**PLANNING APPROVAL,
PLANNED UNIT DEVELOPMENT &
SUBDIVISION STAFF REPORT**

<u>NAME</u>	Ashland Place United Methodist Church, Inc.
<u>SUBDIVISION NAME</u>	Ashland Place UMC Subdivision
<u>LOCATION</u>	5, 7 and 15 Wisteria Avenue, 2315 Old Shell Road and 2312 Dauphin Street (Southwest corner of Old Shell Road and Wisteria Avenue, extending to the North side of Dauphin Street, 160'± West of Wisteria Avenue, and 380'± West of Wisteria Avenue)
<u>CITY COUNCIL DISTRICT</u>	District 1
<u>PRESENT ZONING</u>	R-1, Single-Family Residential District
<u>AREA OF PROPERTY</u>	2 Lots / 4.6± Acres – Subdivision 1 Lot / 3.96 ± Acres – PUD and Planning Approval
<u>CONTEMPLATED USE</u>	Planning Approval to amend a previously approved Planning Approval to allow the construction of an administrative office, classroom building, outdoor patio and expanded retention pond in an R-1, Single-Family Residential District, Planned Unit Development Approval to amend a previously approved Planned Unit Development to allow the construction of an administrative office, classroom building, outdoor patio and expanded retention pond at an existing church, and Subdivision approval to create two lots.

SUBDIVISION PLAT

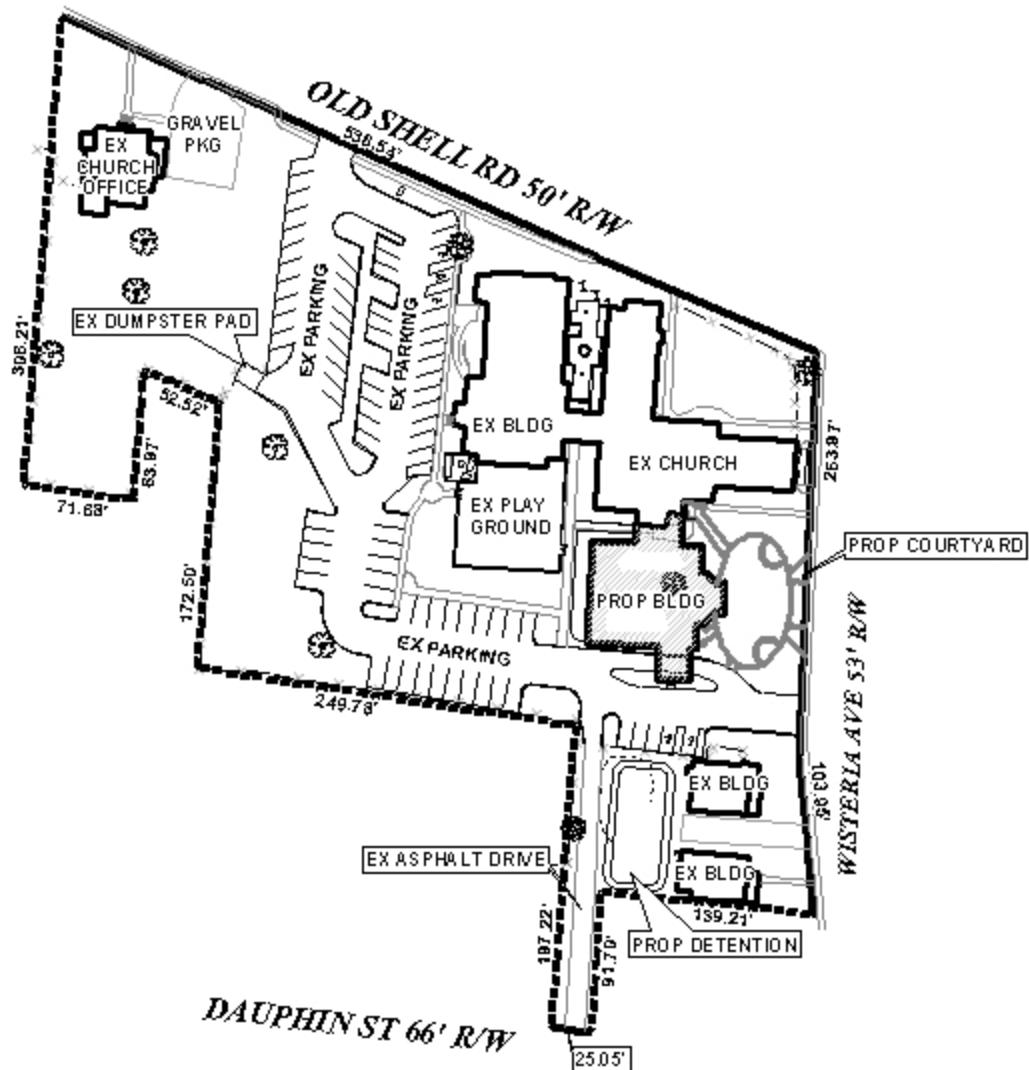
Regarding the Subdivision plat and the site plans, the notes regarding setbacks from rights-of-way should also be depicted and labeled on the drawing.

Subdivision: The request is recommended for Holdover until the April 2nd meeting, with 7 copies of the revised preliminary plat due by March 20th, so that the following revision can be made:

- 1) Depiction and labeling of the 25-foot minimum building setback line from Old Shell Road and Wisteria Avenue, and depiction and labeling of the minimum building setback line along Dauphin Street so that it is 75-feet from the centerline.
